**REPORT TO:** Environment and Urban Renewal Policy and Performance Board

**DATE:** 28<sup>th</sup> January 2015

**SUBJECT:** Partial Revocation of Existing Waiting & Loading Restrictions School Way, Widnes

**Temporary Provision of  
 Local Parking Facilities,  
 School Way, Widnes**  
 Scale: NTS Date: Oct. 2014  
 Drawn: SJDrg. No. 8971A

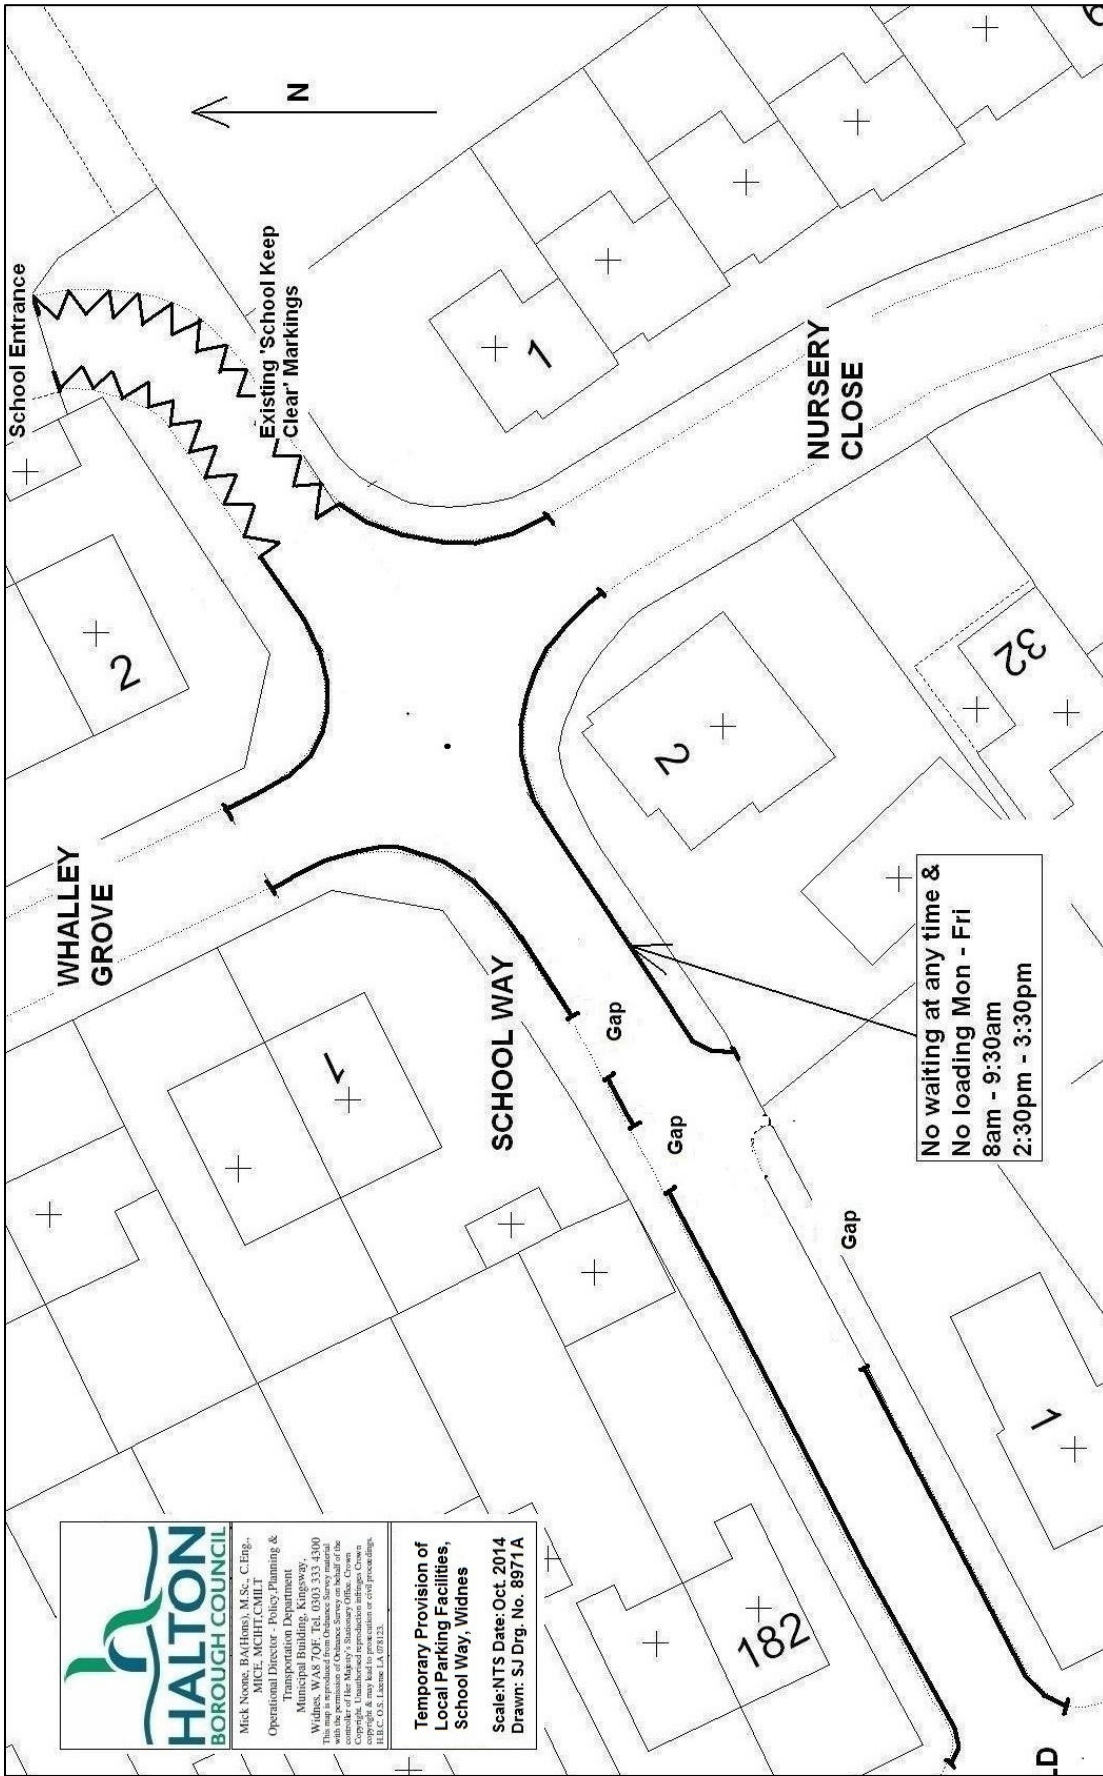
site meetings requesting minor alterations to the restrictions to permit a degree of local parking culminating in the introduction of three experimental 'gaps' in the restrictions as shown in Drg. No 8971A in Appendix 'A'.

[1] There is "*..no parking space outside of our home,*" which is not strictly correct as examination of the site plan in the Appendices will show. In addition, outside of the short school opening and closing times, parking on the double yellow lines to load and unload vehicles is permitted.

**Proposed Partial Revocation of 'At Any Time' Waiting and Loading Restrictions, School Way**  
Mon-Fri 8am - 9:30am & 2:30pm - 3:30pm  
Scale: NTS Date: Oct. 2014  
Drawn: SJ Drg. No. 8971

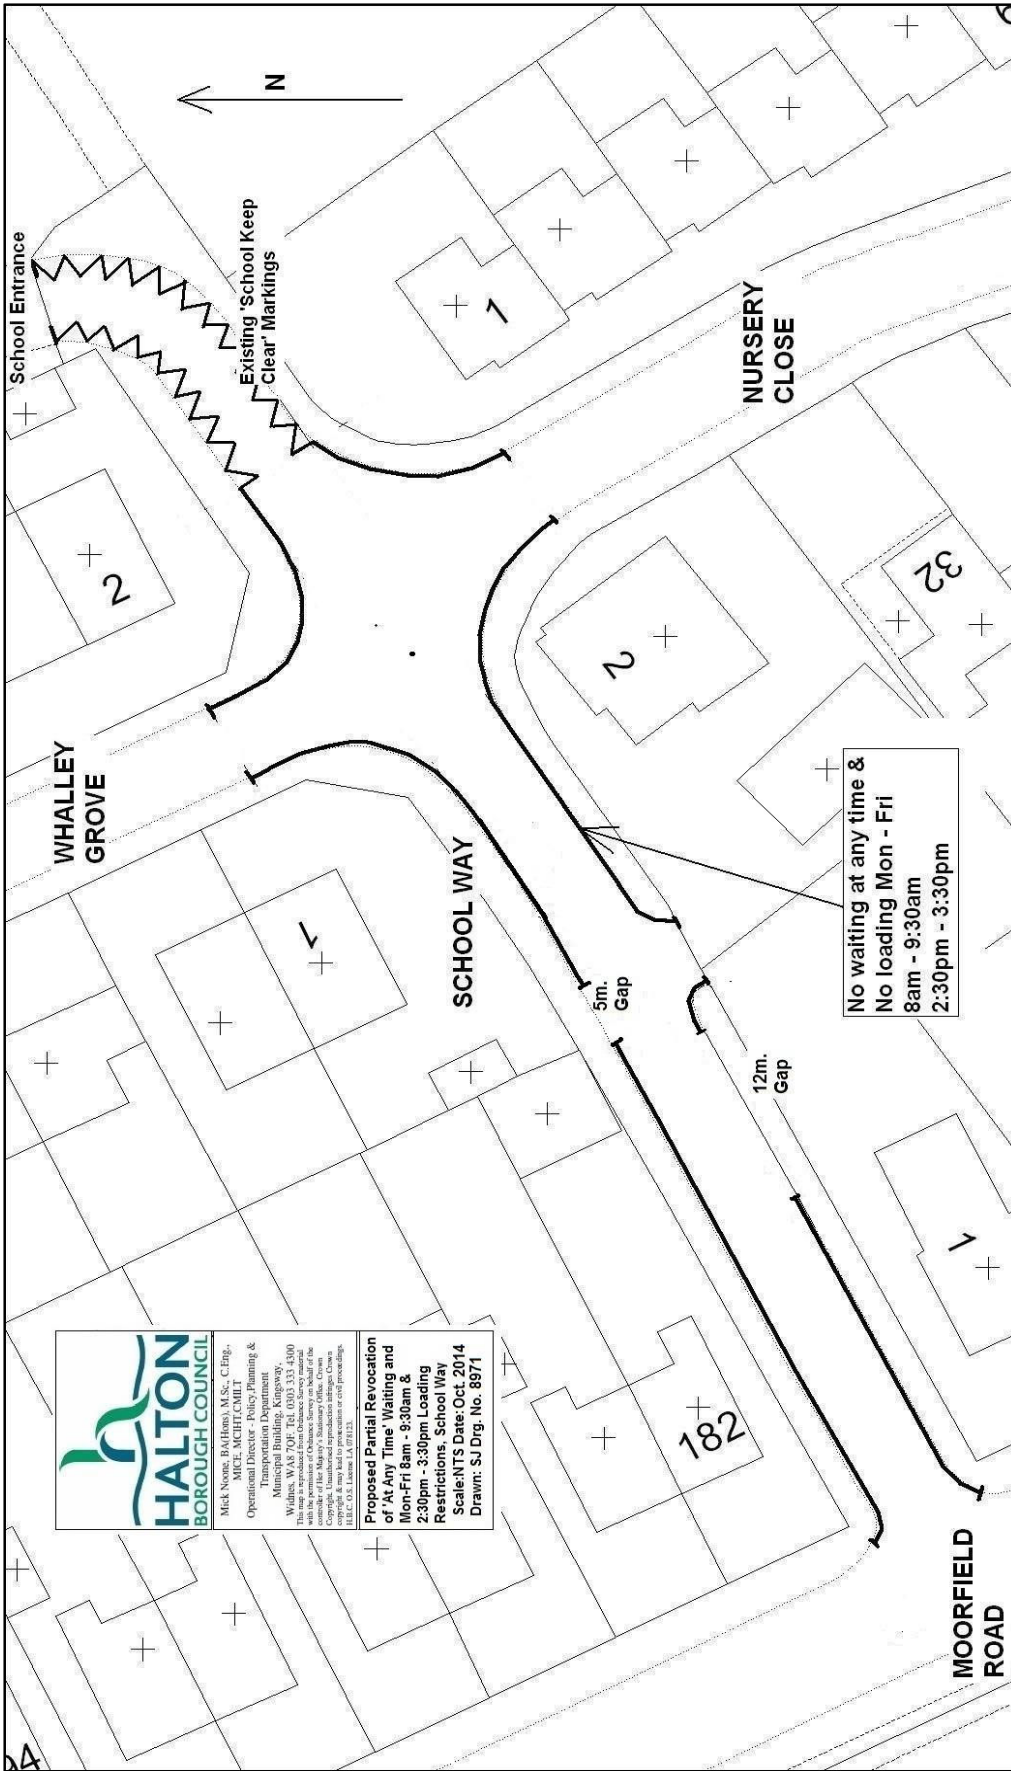
3.3 In order to formalise the arrangements, after considering all the public comment received up to that time, in November 2014 using delegated powers and after consultation with the ward councillors, the Executive Board member – Transportation and Cheshire Police, the Operational Director (Highways, Transportation and Logistics) issued approval to advertise the introduction of a Traffic Regulation Order to revoke limited parts of both the Halton Borough Council (Various Roads, Widnes)(Prohibition of Waiting) Order 2011 and the Halton Borough Council (Various Roads, Widnes)(No Loading) Order 2011 relating to School Way, Widnes as shown graphically in Appendix 'B'. This proposed Order would have formalised and made permanent two of the three previously experimental 'gaps', whilst closing the third, retaining the vast majority of the 2011 restriction coverage. The 'gap' intended for closure was that closest to Whalley Grove, on the north side of School Way.

3.4 The proposed modifications to provide limited areas for unrestricted waiting were intended as a compromise between the various views expressed by adjoining residents over recent years. However in response to the November 2014 proposals and consultation, 10 objections were received. One originated from residents of 1 Whalley Grove (at the south-west corner of the School Way/Whalley Grove junction) who wanted to retain all the experimental 'gaps' near their home and opposed the closing of the 'gap' closest to Whalley Grove, on the north side of School Way. The letter of objection is reproduced as Objection 1 in Appendix 'C'.

3.5 As shown on the drawings, 1 Whalley Grove is a property with an off-road driveway leading from School Way to a garage, and frontage parking on Whalley Grove. However, there are two core tenets in the letter of objection:

3.6 The greater number of objections, reproduced as Objections 2 to 10 in Appendix 'C', cover basically similar issues stating that the presence of vehicles parking in 'gaps' on opposite sides of School Way creates a chicane effect which:

In view of these responses, it is recommended that just one 'gap' be retained and formalised, that being the one on the south side of School Way adjacent to No.1 School Way.

**Proposed Partial Revocation  
 of 'At Any Time' Waiting and  
 Loading Restrictions, School Way**  
**Mon-Fri 8am - 9:30am &  
 2:30pm - 3:30pm Loading**  
 Scale: NTS Date: Jan. 2015  
 Drawn: SJ Drg. No. 8971 B

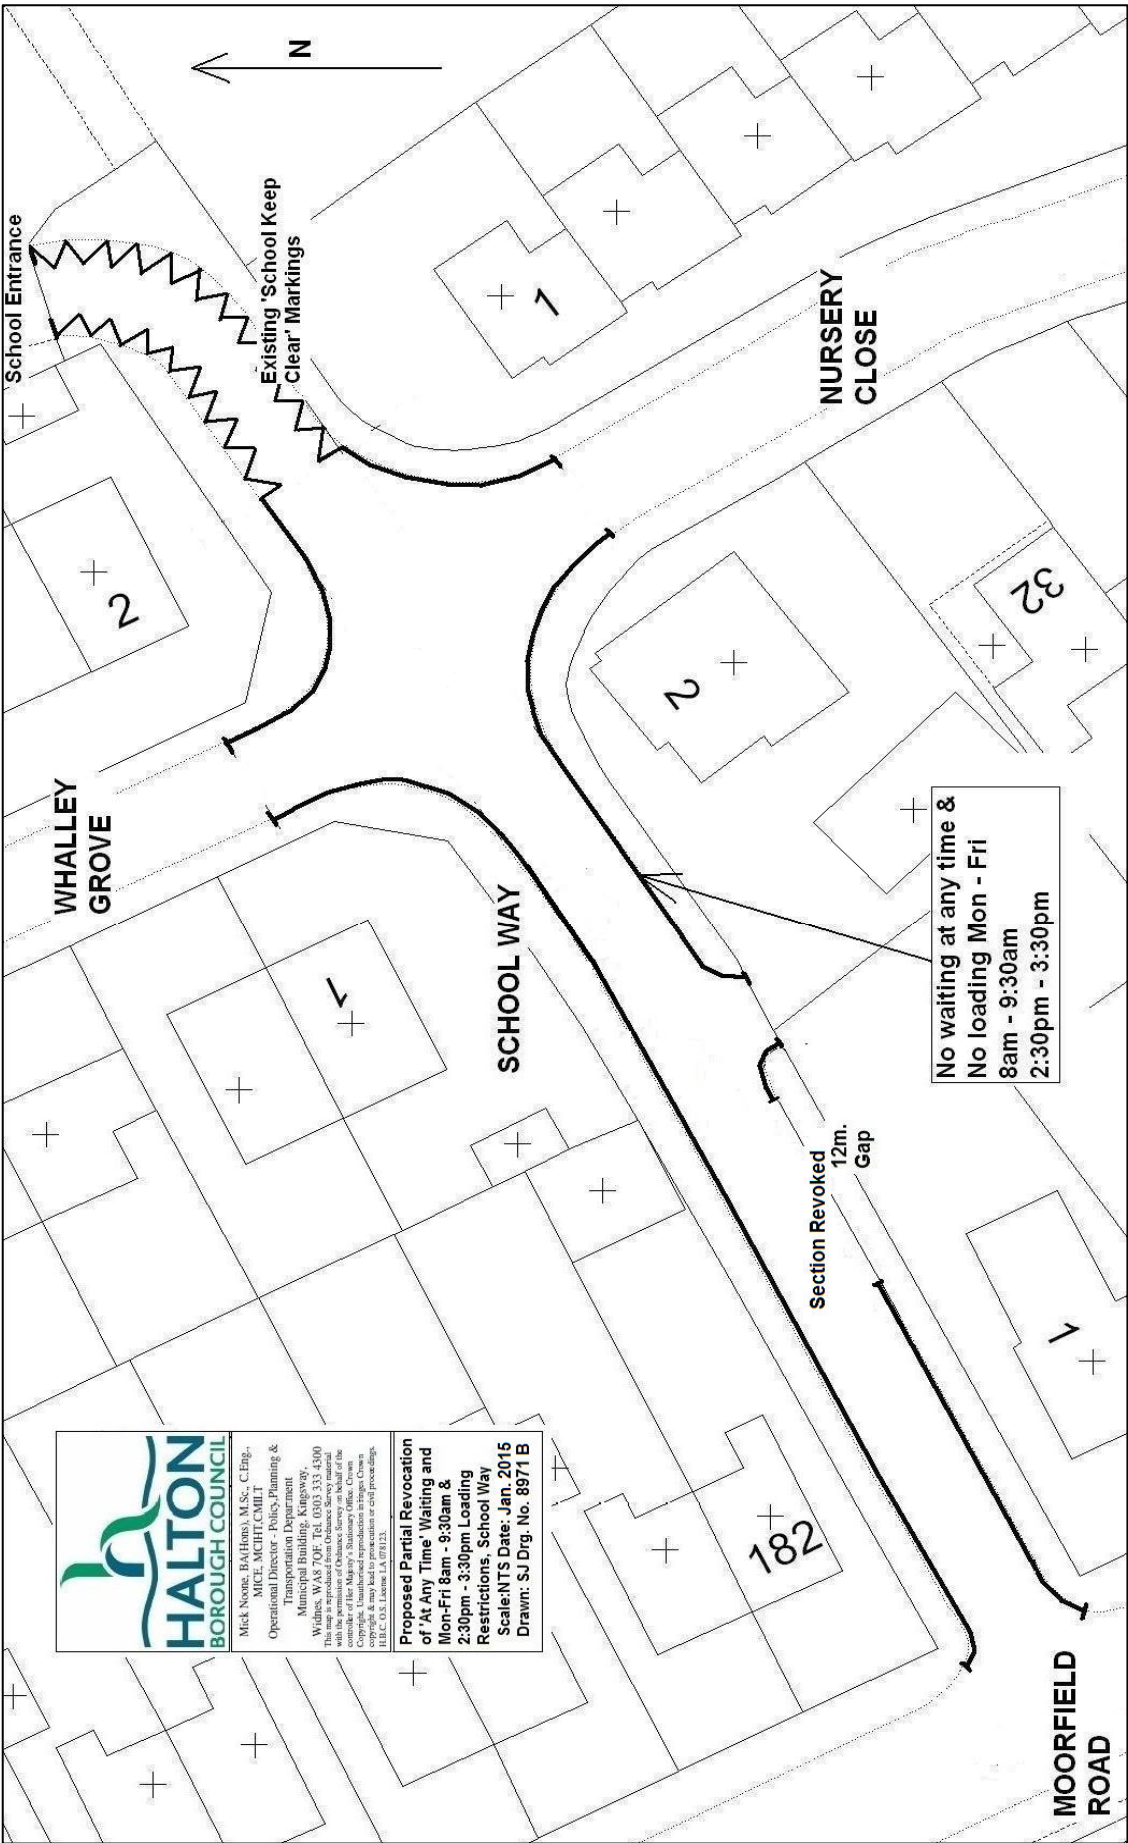
[b] Details: Revocation of the following section of the above traffic regulation Orders:  
School Way, south side starting from 24m. for a distance of 12m., measured from the east kerb line of Moorfield Road, Widnes.
